MICROLIGHT AIRWORTHINESS APPROVAL NOTE

MAAN NO: 2073

TITLE: Microlight Airworthiness Approval Note 2073,
Shadow Service Bulletin BMAA 2073.

<i>Title: Shadow variants: Inspection of hanger tube brackets</i>	
<i>Reference: SB BMAA MAAN 2073 issue 1</i>	<i>Applicability: All UK Shadow variants administered by the BMAA</i>
<i>Issue date: 30 March 2007</i>	
Recommended inspection.	
This SB should be actioned before the next Permit Revalidation inspection.

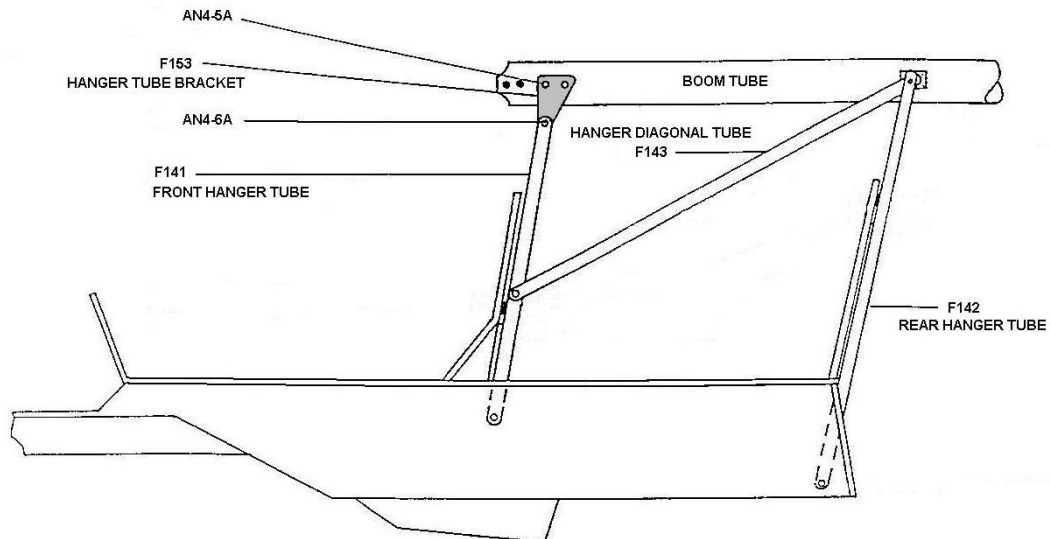
1. Firmly chock the main wheels to prevent them moving during the inspection.
2. From the rear cockpit, equipped with a good light source, inspect the F153 plates for cracks and any evidence of movement or fretting within the hanger tube and the bolts for tightness.

3. Whilst inspecting the plates, ask a helper to gently push the wing fore and aft and check visually, and by feel, for any signs of movement between the plate and the hanger tube.

4. Next try using a firm vertical force applied at the point where the wing strut attaches to the wing. **WARNING:** do not exert lifting pressures at the wing tip.

5. Repeat steps 3 & 4 on the other wing.
6. Any evidence of undue movement or fretting should be investigated. If unsure, the F153 may be removed from the aircraft for a detailed inspection. If everything appears normal, then return the aircraft to service.
